## CMB Meeting Minutes #157

REFERENCE Project No. M544.1, Contract No. 149 Task 1-8.02

SUBJECT: Configuration Management Board Meeting # 157– Rev. No. 0

TRACK  
PLAN AND PROFILE  
SB 131+00 TO 134+50

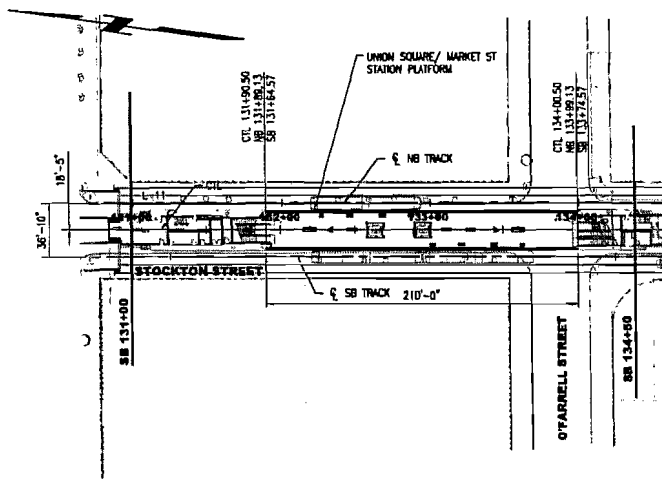
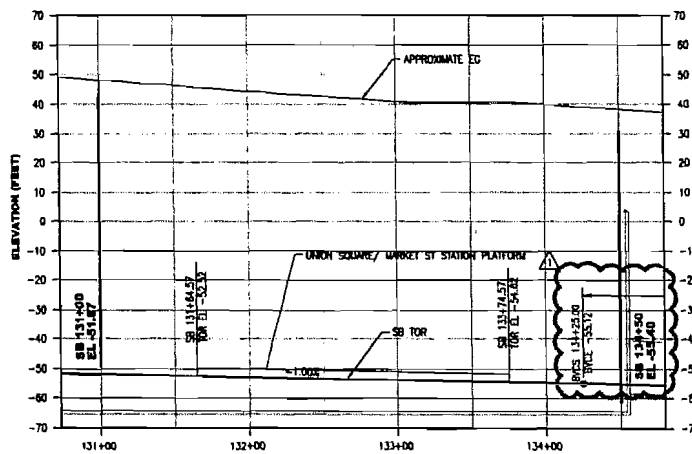
Modify Contract 1300 plans affected by the lowering of tunnels. This change affects the profile of track and overhead contact system between UMS and YBM, and the sump pump at cross passage 5. See list below.

The analysis, Rationale Supporting Revised Alignment of the Central Subway Tunnels by PB/T, dated June 26, 2013, concluded that the combination of vertical and horizontal curves in the trackway south of the UMS Station without increasing the length of vertical curve did not compromise rider comfort, maintenance, safety issues, or the design speed of 25 mph. UMS and YBM station designs are not affected by the new profile of the tunnels.

## **Rationale Supporting Revised Alignment of the Central Subway Tunnels**

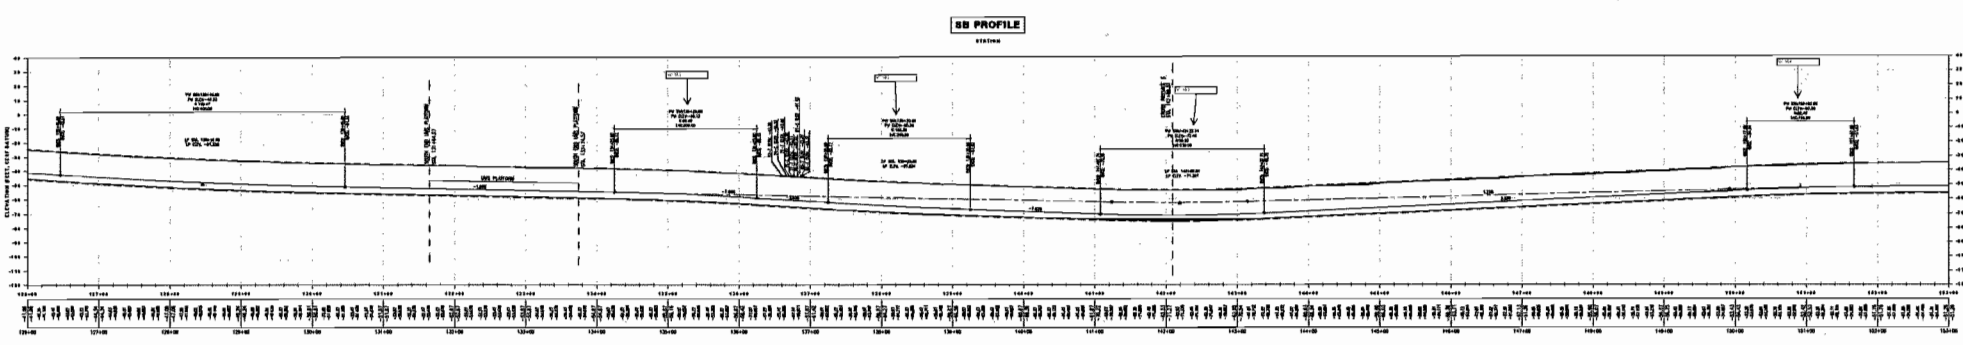
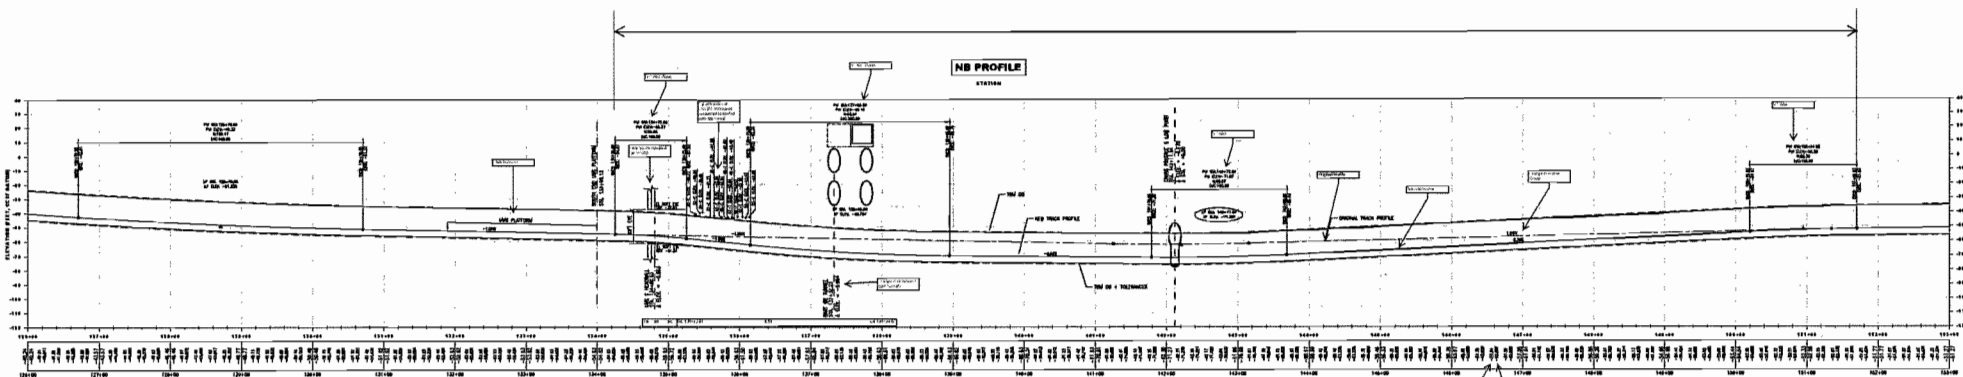
Due to the severe right-of-way constraints imposed by having to maintain the tunnel alignment under Stockton Street, Market Street and Fourth Street, and staying within negotiated easements on both sides of Market Street, a change to the horizontal alignment of the NB tunnel was deemed not feasible. In order to provide clearance to the micro piles the NB tunnel grade south of the South Headwall soft eye was increased from -1.00% to -4.90% with two new vertical curves added.

In order to conform to the requirements of the Muni Design Criteria (Section 7.2.2.3 and 7.2.2.6) at the applicable 25 MPH design speed the rate of change in grade would be limited to 1.06% per 100 ft and the length of the vertical curve (designated NB1 in Figure 1 excerpted from Attachment 1) would need to be 369'. The length of vertical curve that is physically possible due to the location of the UMS platform and other constraints to the alignment is 100'. This is a large difference, however, for the horizontal and vertical curve combination south of UMS Station. The primary reason to increase vertical curve length in a horizontal curve is to reduce the vertical acceleration that occurs when passing through a vertical curve. This vertical acceleration is typically of significance only in a crest vertical curve at higher speeds. The effect is usually not large at low speed, and in this case a large increase in the vertical curve length that would be required by the Muni Design Criteria formula for "Combined Horizontal and Vertical Curvature", appears to be unwarranted.

This analysis shows that the large increase in vertical curve length that would be required by the Muni Design Criteria formula for "Combined Horizontal and Vertical Curvature" is unwarranted. It appears that no change is needed for either the horizontal curve or the vertical curves in this area for the current assumed design speed of 25 MPH. If any change were to be considered, the only one that would have any benefit would be to increase the applied superelevation for curve C-11 by  $\frac{1}{8}$  to  $\frac{1}{4}$  inch. Per the Muni Design Criteria 7.2.1.3 the Recommended Maximum design unbalance is 3.0 inches; absolute maximum is 4.5 inches. The calculated values of unbalance with the proposed revised alignment are slightly over 3.0 inches, but well under the 4.5 inch absolute maximum.

The slight increase in superelevation mentioned in the analysis is not considered to be essential, however, it could be considered by the track designers during their revisions of the reference track design needed to reflect the profile changes described in this analysis.

**THIRD STREET LIGHT RAIL PROGRAM - PHASE 2 CENTRAL SUBWAY  
CONTRACT # 1386 STATIONS, SURFACE, TRACK AND SYSTEMS  
TRAFFIC CONTROL PLAN  
YERBA BUENA / MOSCONE STATION - STAGE 2 TRAFFIC MODIFICATIONS**

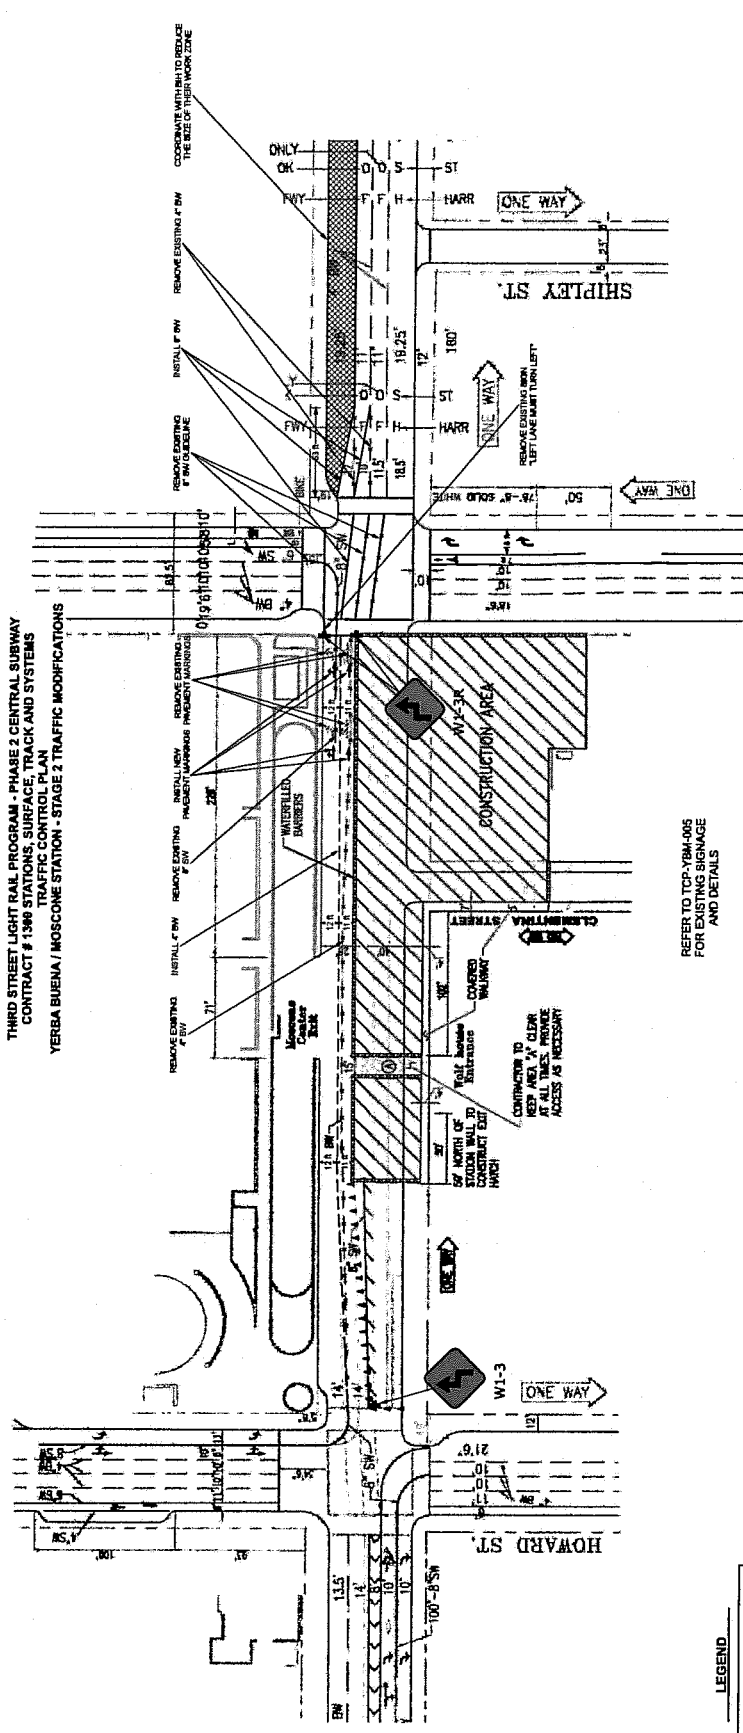
7-	R. Redmond and M. Vilcheck presented as an informational item the Contractor's proposed revised Traffic Control Plans which modifies the current Temporary Traffic Routing Plan A Phase 1 to accommodate the equipment for the installation of the slurry wall on the west side. The Contractor will be notified the traffic plan is conditionally approved, which can be rescinded if there is evidence of traffic being impacted.	
8-	R. Redmond presented for information CSDG Task 16 cost tracking report expended for the authorized six-month period of design support under contract 1300. The CMB directed the construction manager to continue to closely monitor the Task 16 budget and to authorize another 6 months of budget similar to the original authorization.	
9-	R. Redmond presented for discussion SFMTA CN 1300 Letter No. 0077 in response to the Contractor letter of CTS Utility Delay. SFMTA's letter stated the Contractor should follow the contract provisions, of demonstrating a time impact for review by SFMTA. (see attached).
